### **Palisades Nuclear Plant Flooding Hazard Re-Evaluation Report**

**DOCUMENT AMENDMENT**

Plant/Unit: Palisades Nuclear Plant Page: 1 of 3  
 Contract No.: F.502242 - C-02-51115 <sup>50</sup> Safety Related: ☒ Yes ☐ No Document Amendment No: 159 - 9236786 - 000  
 Amended Document No.: 51 - 9226987 - 000  
 Amended Document Title: Palisades Nuclear Plant Flooding Hazard Re-Evaluation Report

**Figure 3-18: Selected Prominent Bathymetric Features**

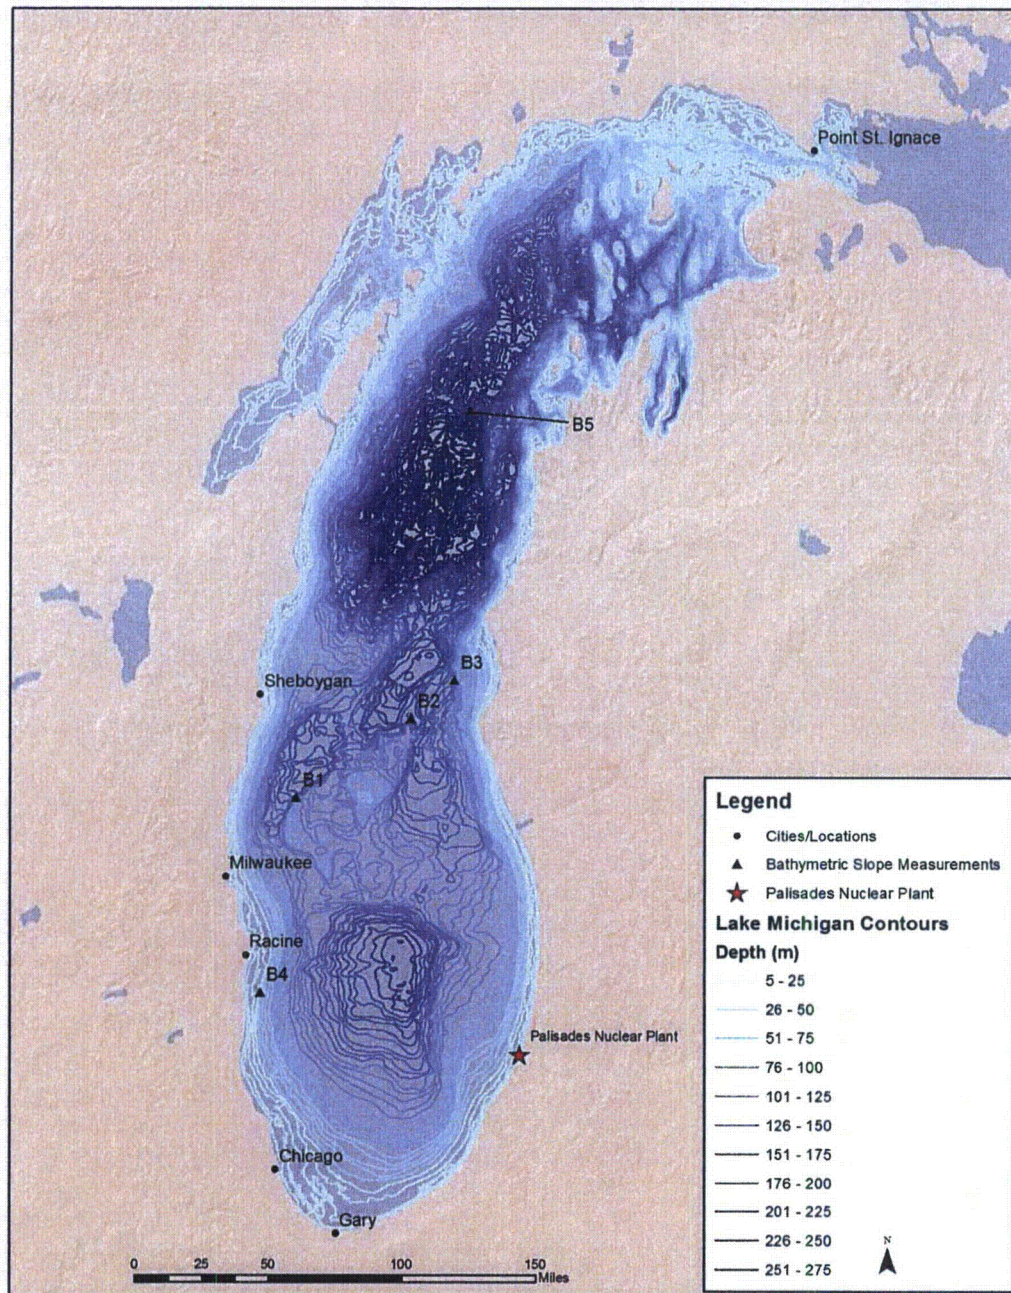
Referring to Document Amendment No. 159-9236737-000 which was issued to change several figures in Document No. 51-9224283-000 - Palisades Nuclear Plant Flooding Hazard Re-Evaluation - Screening for Tsunami, the subject Document Amendment changes Figures 3-18 and 3-19 in Document No. 51-9226987-000 - Palisades Nuclear Plant Flooding Hazard Re-Evaluation Report, since Figures 3-18 and 3-19 are the same figures as those in the Tsunami Screening. As such, the 'star' designation for the Palisades Nuclear Plant on Figures 3-18 and 3-19 of the Flooding Hazard Re-Evaluation Report needs to be shifted slightly to the north along the southeastern shore of Lake Michigan. Note that these figures were provided for illustration purposes and were not pertinent to the technical content of Document No. 51-9226987-000.

The attached versions of Figures 3-18 and 3-19, (i.e., page 77 of 142 and page 78 of 142, respectively) from Document No. 51-9226987-000 show the correct 'star' designation for the location of the Palisades Nuclear Plant on the southeastern shore of Lake Michigan.
